No. 2821

Mislabeled ARINC Rack Connectors

SERVICE LETTER

Proper Silkscreen Orientation

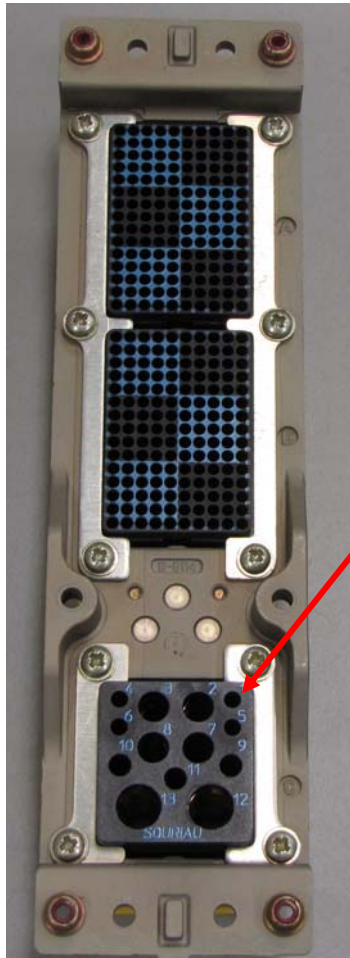
Universal Avionics has received several defective ARINC rack connectors from its approved supplier. Several instances of the power cavity bottom plug have been identified as being silk-screened backward and should be returned to Universal for replacement connectors. See the following illustration for the correct markings.

These defective connectors have the potential to cause incorrect wiring by installers resulting in equipment damage when applying power to the unit.

If you have UASC Installation Kit Part Numbers **K12075**, **K12036** or **K12028-4**, please inspect these kits for defective ARINC connectors.

Connectors may be marked with UASC part number **83303130** and/or the manufacturer's part number **SB612MGLNW2P0004AN**.
